**Environmental Impact Assessment (EIA) Ordinance, Cap. 499
Application for Variation of an Environmental Permit**

**Project Title: Hong Kong-Zhuhai-Macao Bridge – Hong Kong Boundary Crossing Facilities
(Application No. VEP-498/2016)**

ENVIRONMENTAL PERMIT TO CONSTRUCT AND OPERATE A DESIGNATED PROJECT
建造及營辦指定工程項目的環境許可證

Figure 27
圖 27

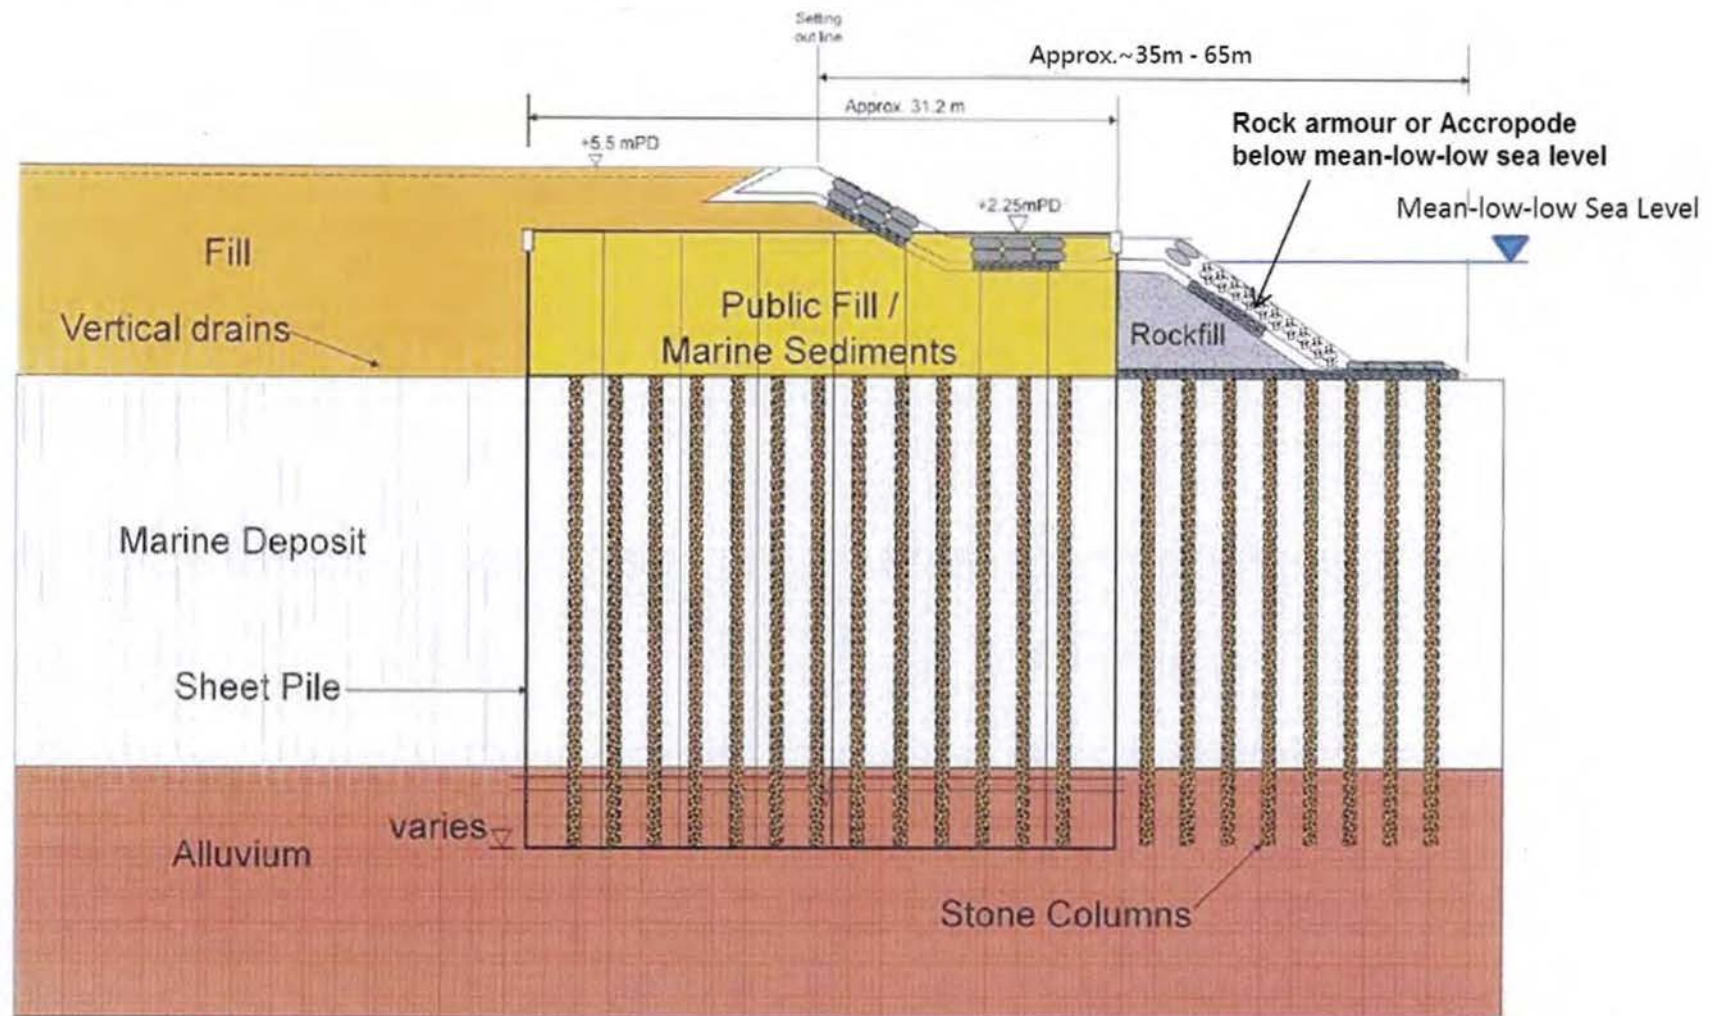
Application No. 申請書編號	Date of Application 申請日期	List of Amendments Incorporated into this Environmental Permit 已包含在本環境許可證內的修訂項目	Date of Amendment 修訂日期
		(2) Add Conditions 3.27 and 3.28 to Part C of the Environmental Permit (No. EP-353/2009/H) (二) 在環境許可證(編號 EP-353/2009/H) C 部加入第 3.27 至 3.28 項條件	
VEP-497/2016	18 February 2016 2016 年 2 月 18 日	(1) Vary Conditions 1.7, 3.24 to 3.26 to Part C of the Environmental Permit (No. EP-353/2009/I) (一) 更改環境許可證(編號 EP-353/2009/I) C 部的第 1.7、3.24 至 3.26 項條件 (2) Add Condition 3.26A to Part C of the Environmental Permit (No. EP-353/2009/I) (二) 在環境許可證(編號 EP-353/2009/I) C 部加入第 3.26A 項條件	25 February 2016 2016 年 2 月 25 日
VEP-498/2016	24 March 2016 2016 年 3 月 24 日	(1) Vary Condition 1.7 to Part C of the Environmental Permit (No. EP-353/2009/J) (一) 更改環境許可證(編號 EP-353/2009/J) C 部的第 1.7 項條件 (2) Vary Figure 27 to Environmental Permit (No. EP-353/2009/J) (二) 修改環境許可證 (編號 EP-353/2009/J)圖 27	11 April 2016 2016 年 4 月 11 日

(Plan originated from Figure 27 of submitted documents dated 24/3/2016 with Application for Variation of an Environmental Permit no. VEP-498/2016)
